DEVELOPMENT APPLICATION ASSESSMENT REPORT

Application Number:	DA2024/1034
----------------------------	-------------

Responsible Officer:	Anaiis Sarkissian
Land to be developed (Address):	Lot 2 DP 1214257, 34 Plateau Road BILGOLA PLATEAU NSW 2107
Proposed Development:	Alterations and additions to a dwelling house including a carport
Zoning:	C4 Environmental Living
Development Permissible:	Yes
Existing Use Rights:	No
Consent Authority:	Northern Beaches Council
Land and Environment Court Action:	No
Applicant:	Craig Lester

D3.7 Side and rear building line

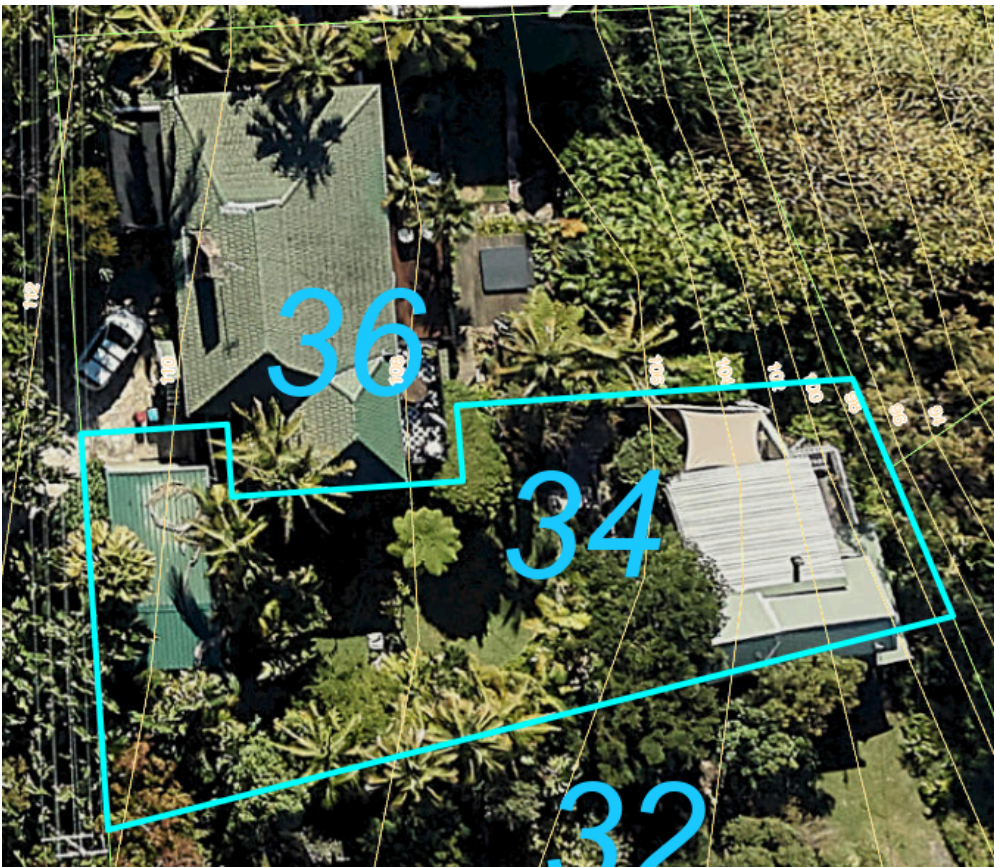
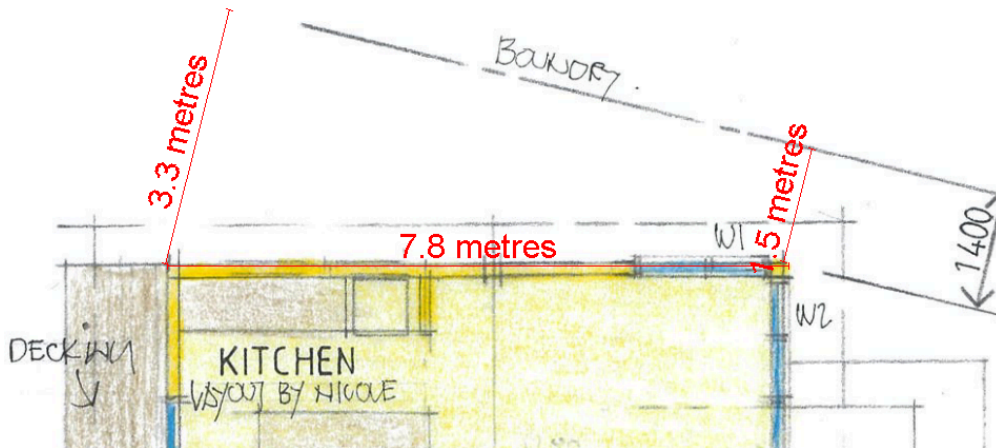
Pursuant to Section D3.7 of the Pittwater 21 Development Control Plan, the minimum side building line for built structures including pools and carparks, other than driveways, fences and retaining walls is 2.5m to at least one side and 1m for the other side.

lower level. Additionally, the proposed upper floor addition is only setback 1.5m from the northern boundary at its closest point; given the building line is not parallel with the boundary, the addition has a ranging setback from 1.5m to 3.3m, as evident in the plan extract below. Furthermore, the site adjoins the property the north such that the subject dwelling is located adjacent to the rear vegetated yard of #36 (refer aerial image below), and therefore the addition poses no amenity impacts upon the living spaces of the neighbouring dwelling.

Figure 1: Northern elevation

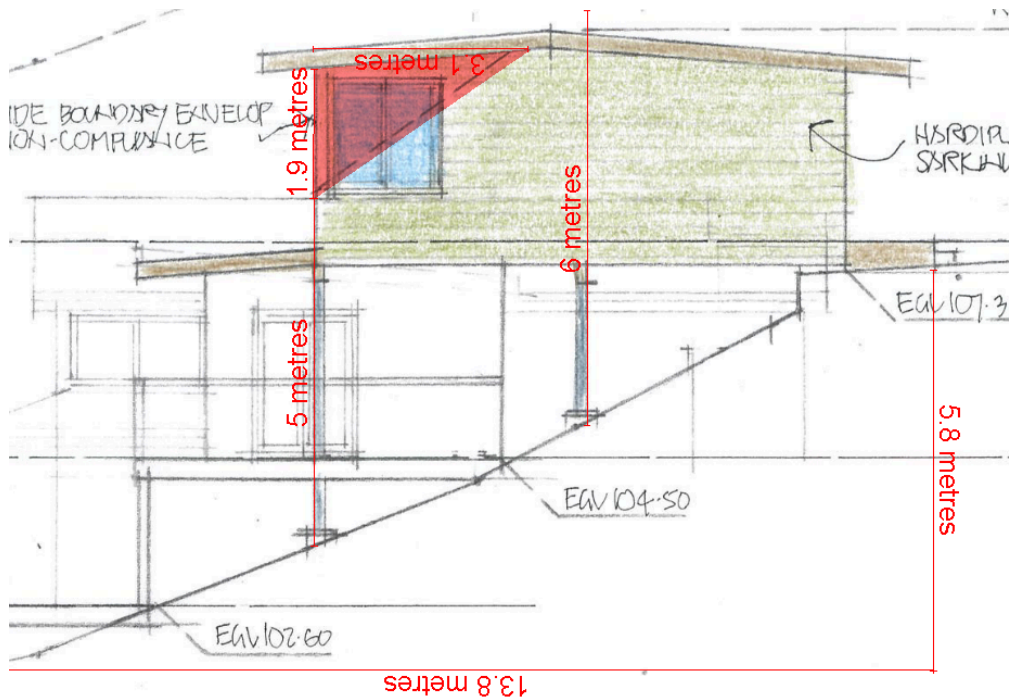
The northern elevation presents an encroachment of 1.9m in vertical height for a horizontal length of 3.1m, resulting in a maximum variation of 38% (1.9m), as shown shaded red in Figure 1 below.

It is important to note that this envelope breach is for a relatively small portion of the northern elevation as the northern boundary and the existing dwelling line are not parallel, and the steepness of the slope increases significantly towards the rear of the site, with the main dwelling sitting on a slope with a gradient of 42%.

Figure 2: Southern elevation

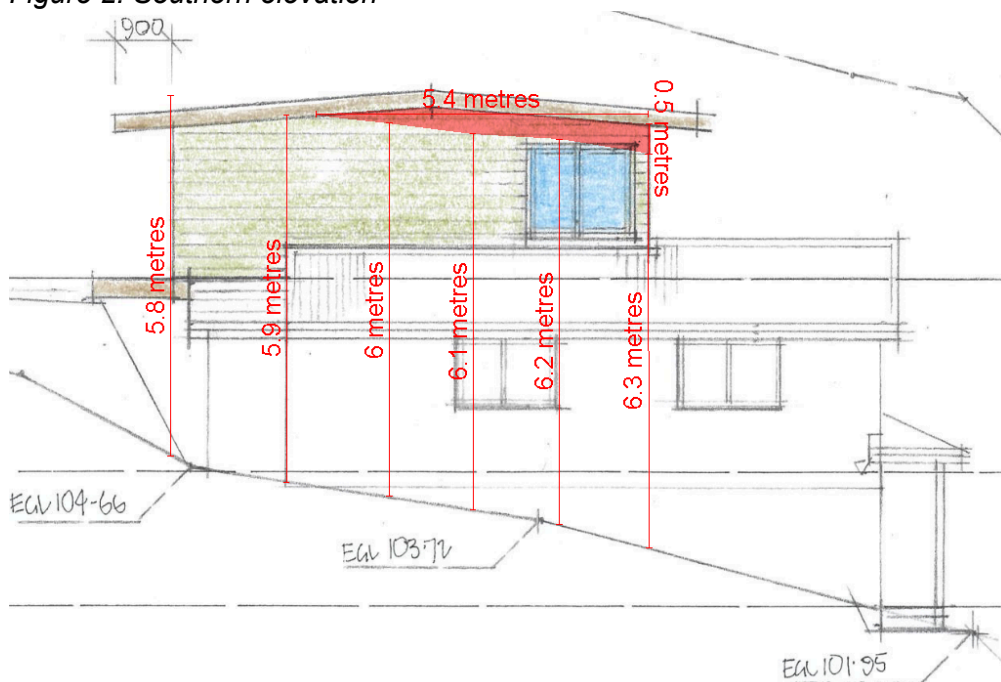
The southern elevation presents an encroachment of 0.5m in vertical height for a horizontal length of 5.4m, resulting in a maximum variation of 7.9% (0.5m), as shown shaded red in Figure 2 below.

It is important to note that this envelope breach is due to the steep sloping topography of the site. Furthermore, the upper floor addition is compliant with the minimum side setback to the southern boundary.
